## HISTORIC AND DESIGN REVIEW COMMISSION

November 2, 2016

**HDRC CASE NO:** 2016-406  
**ADDRESS:** 2219 W MISTLETOE  
**LEGAL DESCRIPTION:** NCB 6829 BLK LOT E 40 FT OF 51 & W 10 FT OF 52  
**ZONING:** R-6 H  
**CITY COUNCIL DIST.:** 7  
**DISTRICT:** Monticello Park Historic District  
**APPLICANT:** Tracy Sloan  
**OWNER:** Tracy Sloan  
**TYPE OF WORK:** Landscaping  
**REQUEST:**

The applicant is requesting a Certificate of Appropriateness for approval to remove lawn and install granite, rocks, drought tolerant plants.

2219 w Mistletoe

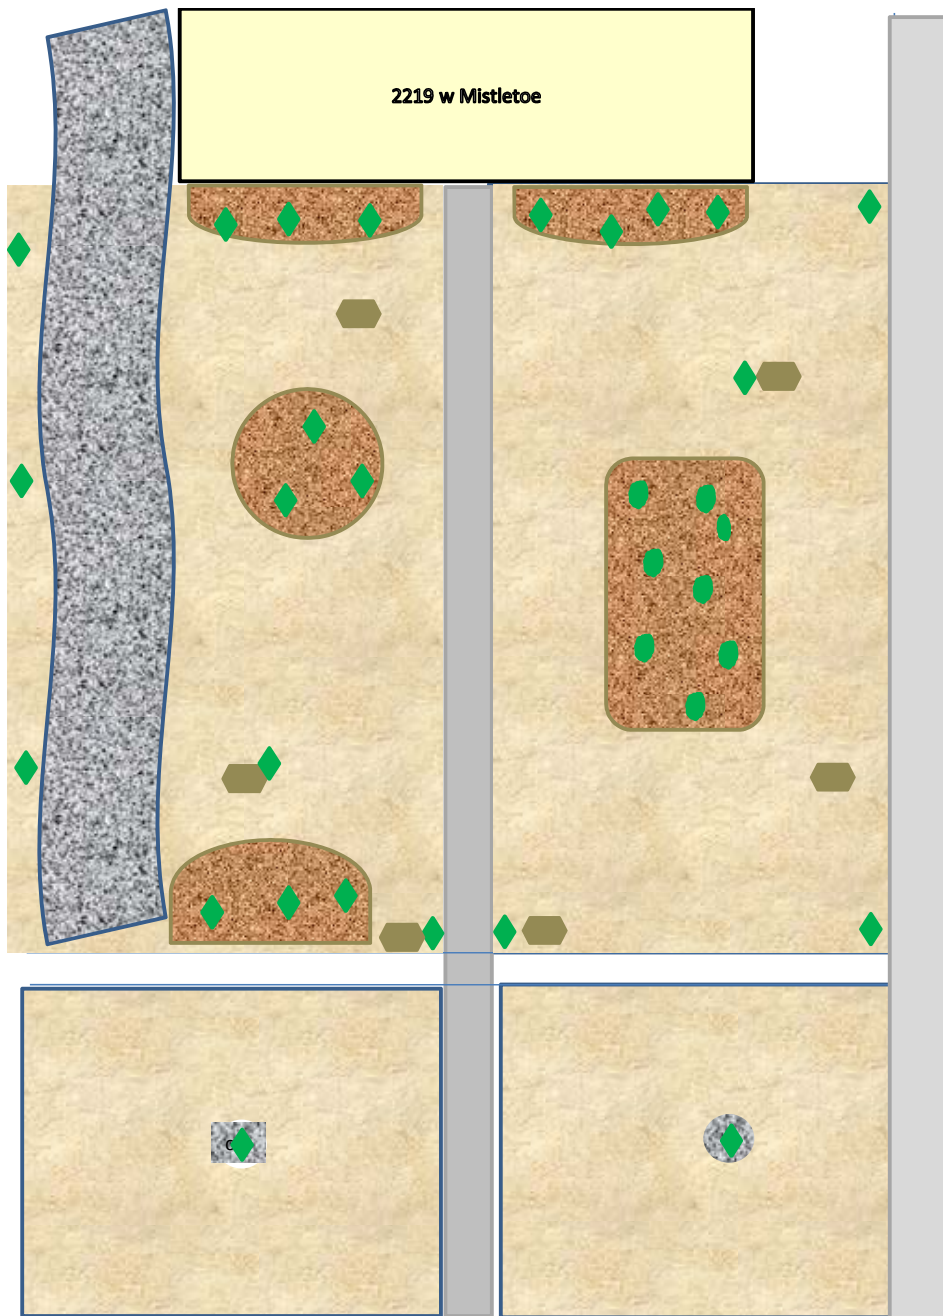
- c. The existing front yard lawn area consists of grass flagstones along the left of the driveway and right bed, seating area with flagstones, dry stone retaining wall along front sidewalk, and shrubs along the front façade. The applicant is proposing to install decomposed granite in the lawn areas, create five beds with hickory creek rocks, install drought tolerant plants in those beds, place boulders around the lawn, and border the left lawn with a strip of river rocks. According to the Guidelines for Site Elements 3.A and 3.B, traditional lawn areas should not be fully removed and replaced, and new pervious hardscapes should be limited to areas that are not highly visible and should not be used as a wholesale replacement. Staff replacing the entire traditional lawn is not consistent with the Guidelines.

- d. The existing planting strip consists of grass and two crepe myrtles. The applicant is proposing to remove all of the grass and install decomposed granite and place river rocks around the crepe myrtles. According to the Guidelines for Site Elements 4.A.ii., maintain the use of traditional lawn in planting strips where a consistent pattern has been retained along the block frontage. Staff made a site visit on October 21, 2016, and found that the planting strips along this particular block solely consisted of lawn. Staff finds the proposal not consistent with the Guidelines.

Staff recommends denial based on findings a through d. Staff recommends the applicant retain at least 50% lawn in the front yard.
